EARLY DESIGN GUIDANCE: ADMINISTRATIVE DESIGN REVIEW

1203 N ALLEN PLACE, SEATTLE, WA

04.12.2023

SDCI PROJECT #3039592-LU  
#3040195-LU

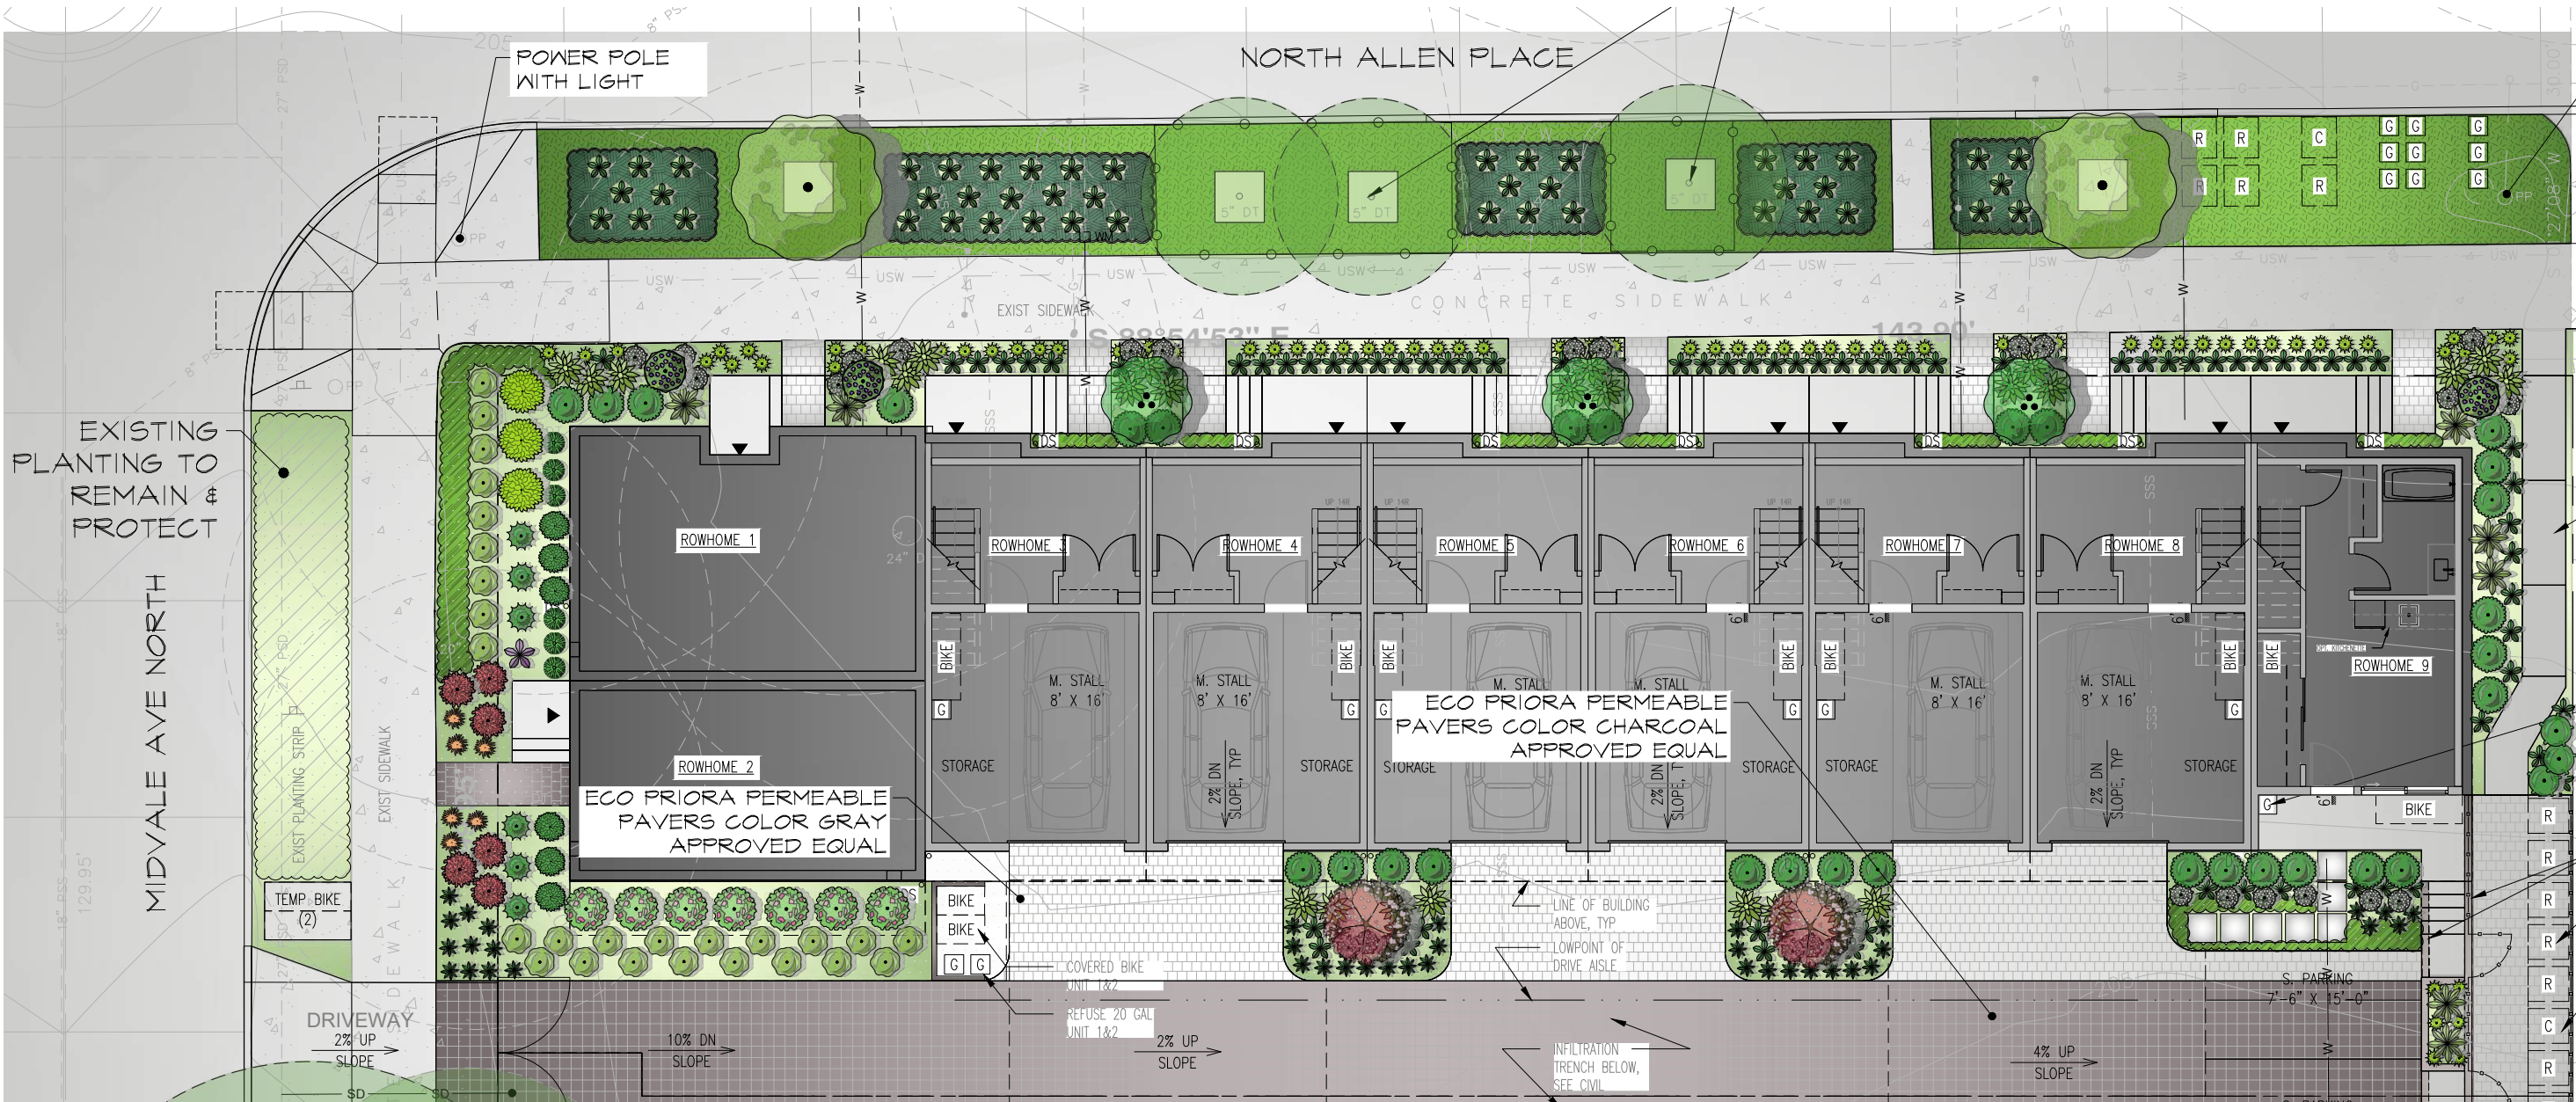
e. **TRASH:** ENSURE THAT THE TRASH ENCLOSURES ARE PROPERLY SCREENED, AND THE DIMENSIONS ARE TO THE STANDARDS SET BY SEATTLE PUBLIC UTILITIES. STRONGLY CONSIDER EXPANDING THE WIDTH OF THE EASTERN PATHWAY FROM THE TRASH STORAGE AREA TO N ALLEN PL SO THAT IT CAN BETTER ACCOMMODATE MOVEMENT OF TRASH RECEPTACLES AND PEDESTRIAN USAGE. ADDITIONALLY, STRONGLY CONSIDER LOCATING THE WIDER PLANTING STRIP AGAINST THE TOWNHOUSE INSTEAD OF THE EASTERN LOT LINE FOR ADDED BUFFER FOR THE UNIT.

*THE TRASH ENCLOSURE DIMENSIONS AND SCREENING HAVE BEEN APPROVED BY THE SEATTLE PUBLIC UTILITIES FOR BOTH LOTS. THE APPROVAL LETTER WAS SUBMITTED TO SDCI. THE CURRENT PATHWAY WIDTH PROVIDES ADEQUATE ROOM TO MANEUVER THE CARTS FOR STAGING. PER SDCI RECOMMENDATION, THE PATHWAY TO CART STAGING HAS BEEN REVISED WITH A 4’ LANDSCAPE BUFFER BETWEEN PATHWAY AND END UNIT. THE VERTICAL BUFFER OF 3.5’-5.5’ BELOW THE FIRST FLOOR OF THE END UNIT HAS BEEN MAINTAINED.*
